MEMORANDUM

TO: Mayor and City Council
VIA: Tanisha Briley, City Manager
FROM: Dennis Enslinger, Deputy City Manager
Rob Robinson, Long Range Planning Manager
RE: Lakeforest Public Hearing – Follow-up Items
DATE: March 7, 2023

During the Joint Public Hearing on the Lakeforest Rezoning and Sketch Plan, three items were brought up by the public: community facilities near Lakeforest; the potential of daylighting an 84-inch stormwater pipe; and the tree stand at the NE corner of Montgomery Village Avenue and Lost Knife Road. The Mayor and City Council requested staff provided more background before the policy discussion. Below is a brief discussion of each of the items that take into account the applicant’s responses, which can be found in more detail at the following link:

84 ACC Pipe Invert PROFILE
 VERTICAL SCALE: 1" = 10'
 HORIZONTAL SCALE 1" = 100'

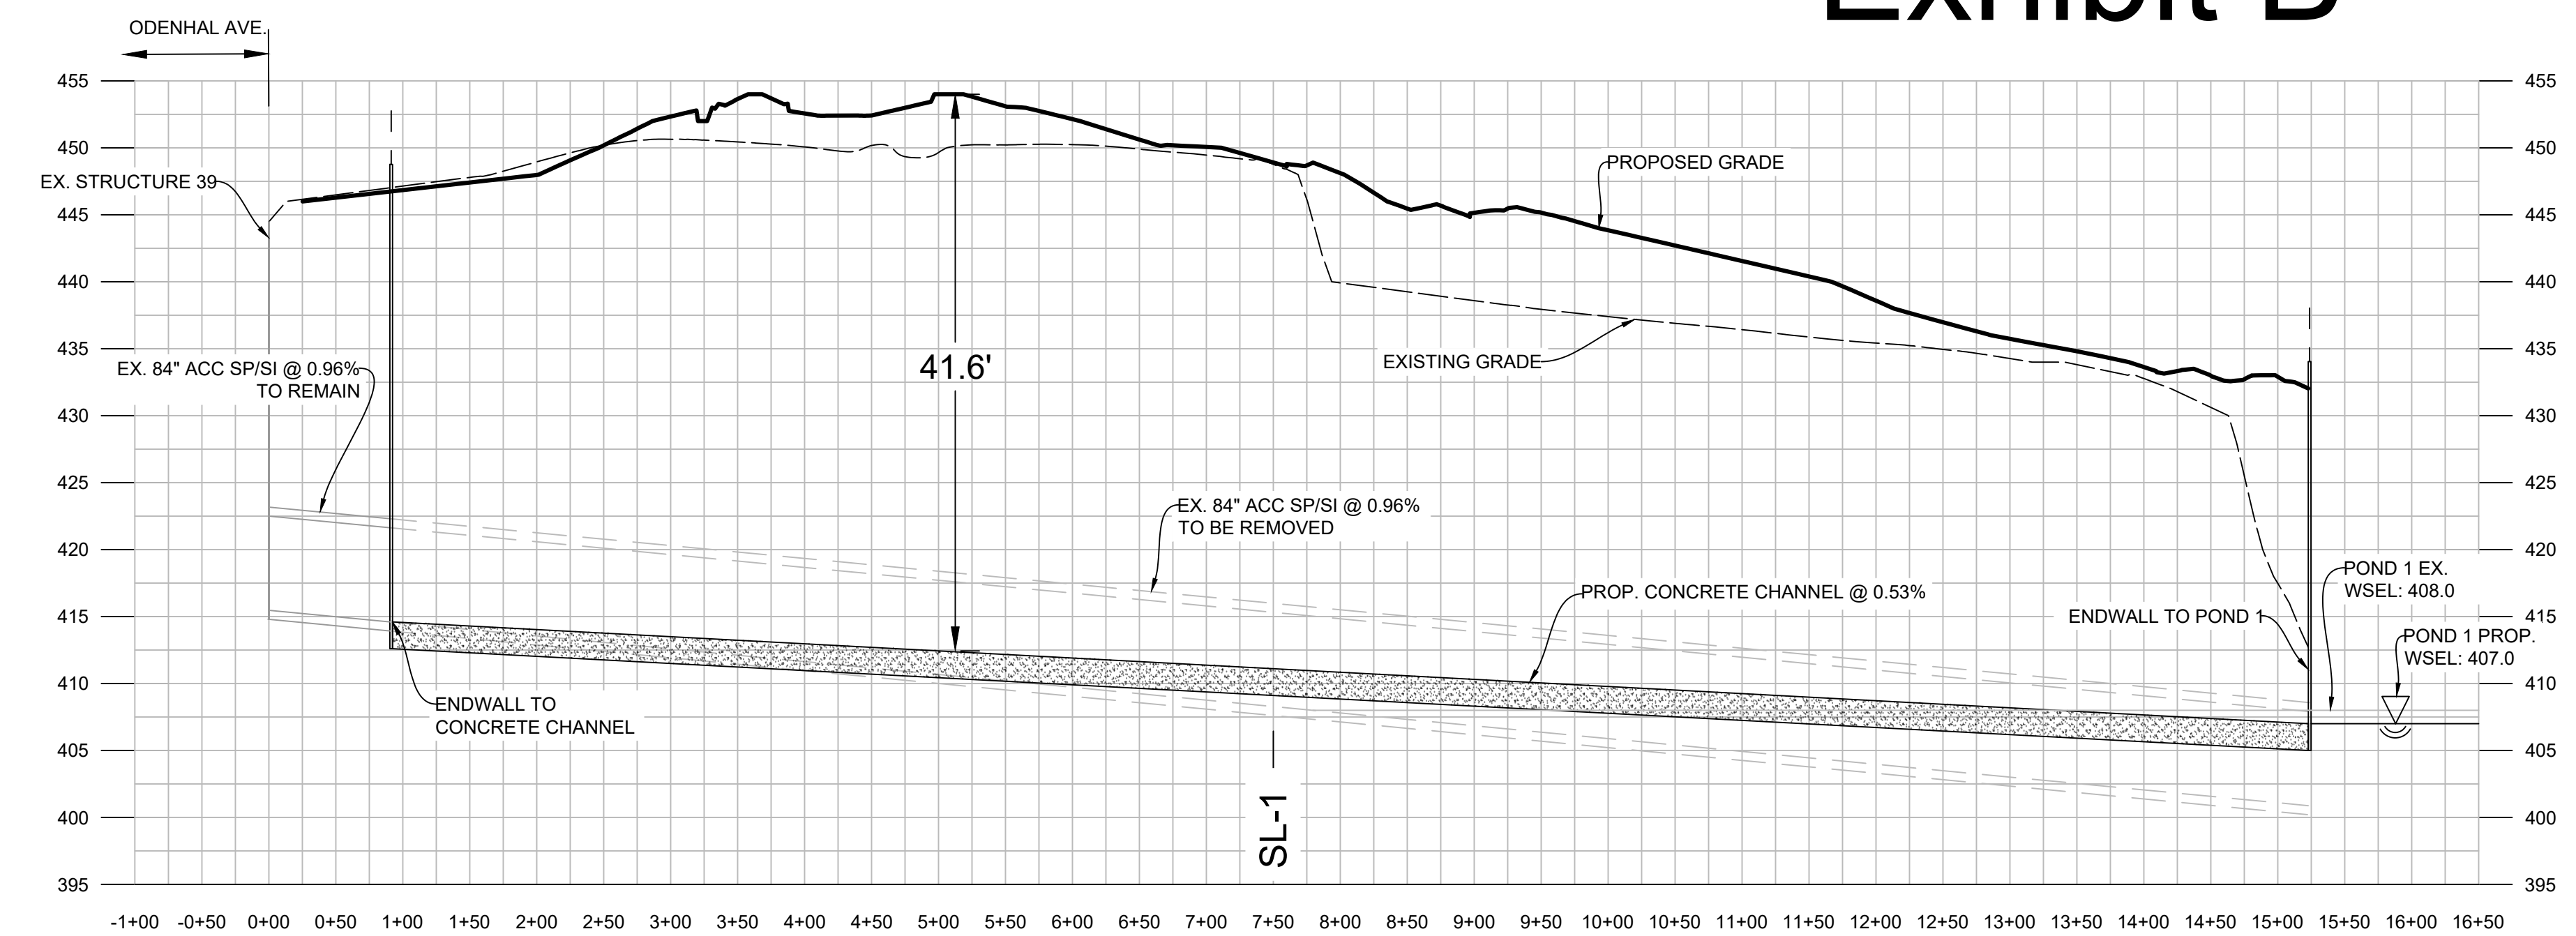
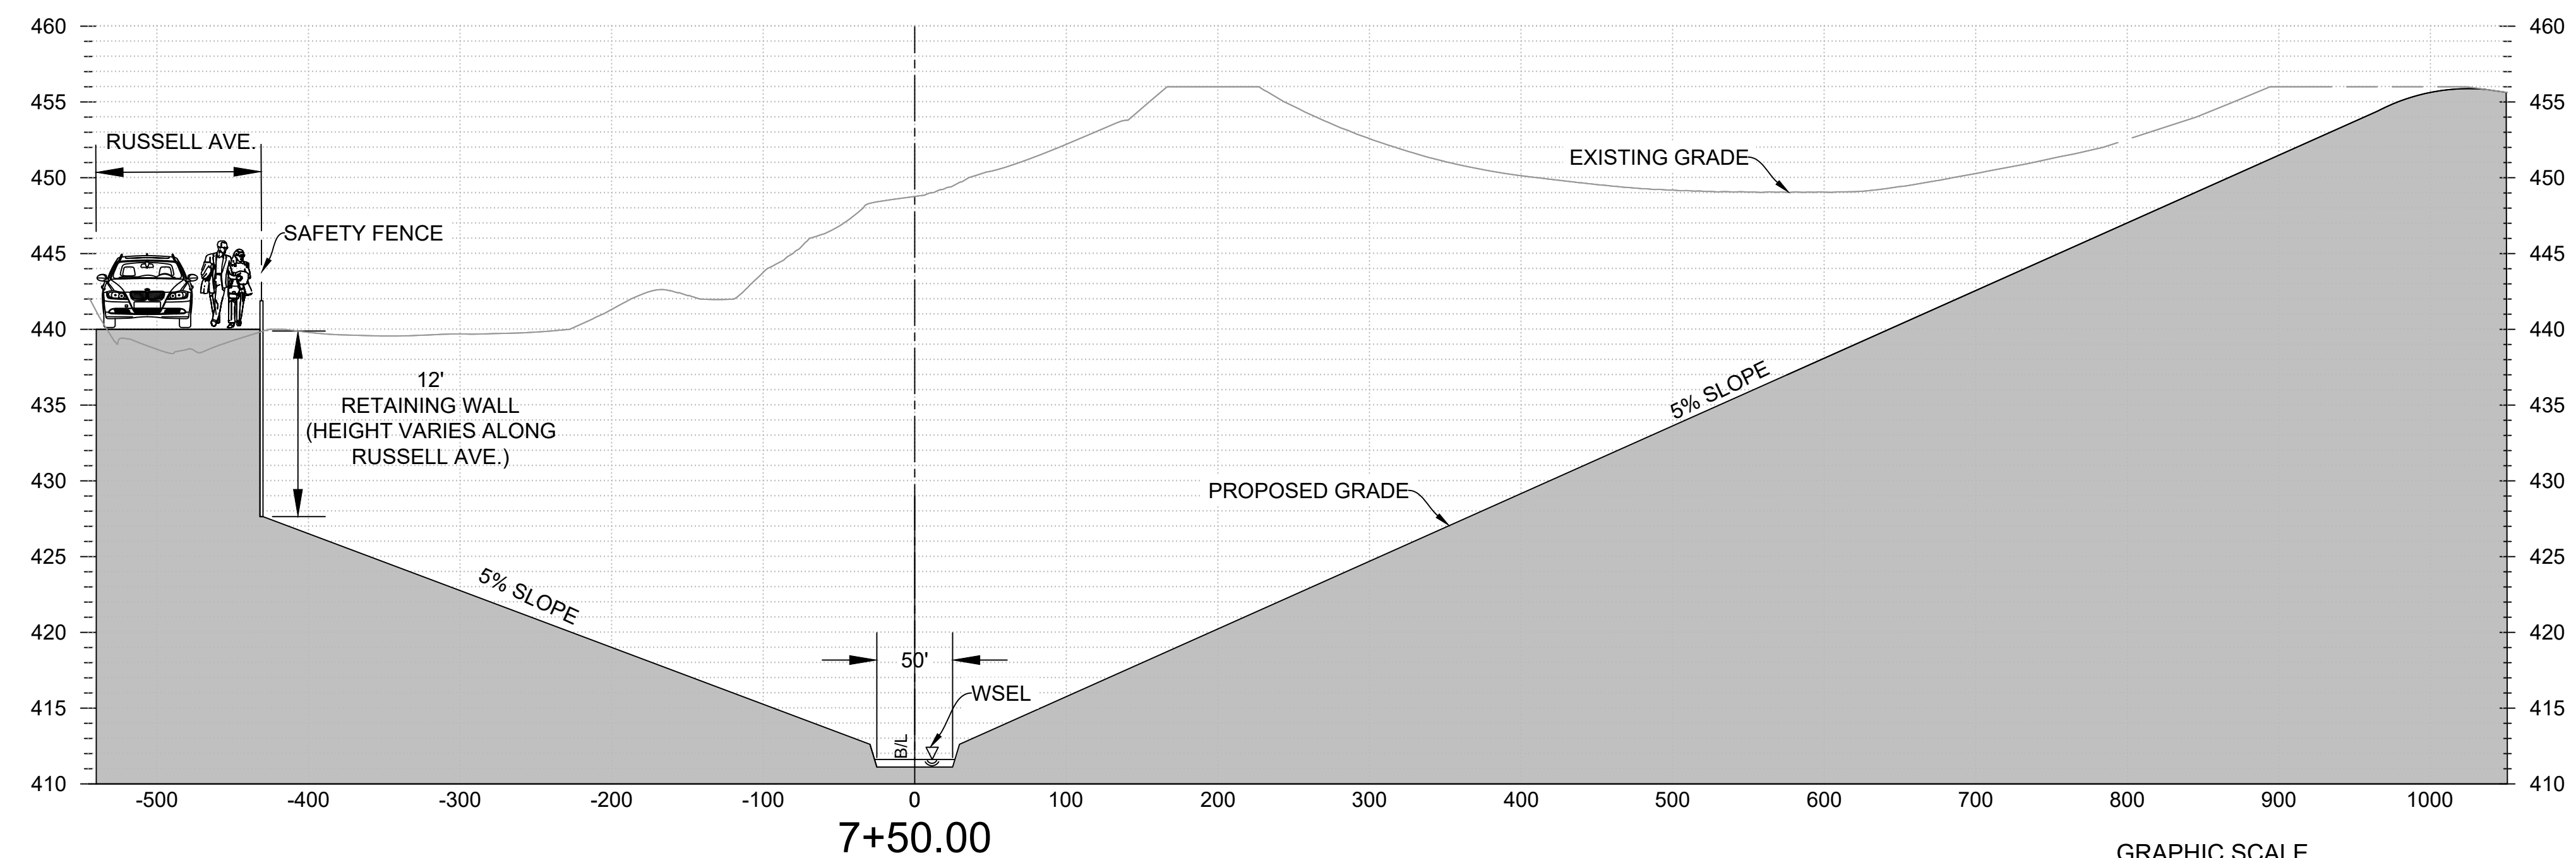
Attachment 2 (Exhibit 2 provided by developer) shows a scenario that reflects a more realistic daylighted stream based on existing conditions. Under the developer’s scenario to accomplish daylighting a pipe 30’ below grade, approximately 37 acres of the developable 75 will be needed to lower the site, provide appropriate side slopes, stream valley buffer, floodplain and floodplain building restriction lines, retaining walls, etc. to make this work. The developer further states that the ‘stream valley’ blocks B, E, F, G, H, I, and J will be eliminated. The east-west roads would not connect.

In reviewing the scenario presented by the developer, stormwater staff has noted that other alignments may provide less of an impact on the overall design. The example alignment increases the impact to the proposed development project and amplifies the depth issue. However, daylighting the stream would certainly impact the site and be a costly endeavor under the best-case scenario,.

While there may be ways to reduce the acreage required to daylight the stream, it is clear that the amount of acreage needed would significantly impact the ability of the developer and the community’s ability to realize the Master Plan and its recommendations. It is clear that daylighting the stream would require reductions in the overall density and potential uses on site due to the loss of developable land. Additionally, it would be difficult to achieve the connected roadway networks (as recommended in the plan) without significant long-term infrastructure maintenance costs, which would ultimately be the responsibility of the public at large.

Staff agrees that, while the possible daylighting of the 84-inch pipe could create a dramatic stream valley park, it would also render the project economically infeasible - not just from the cost side, but from the reduced development capacity perspective. Planning staff does not support daylighting the storm pipe and is concerned that any such requirement will curtail Master Plan envisioned redevelopment and result in continued C-2 Zoning and vested operations.
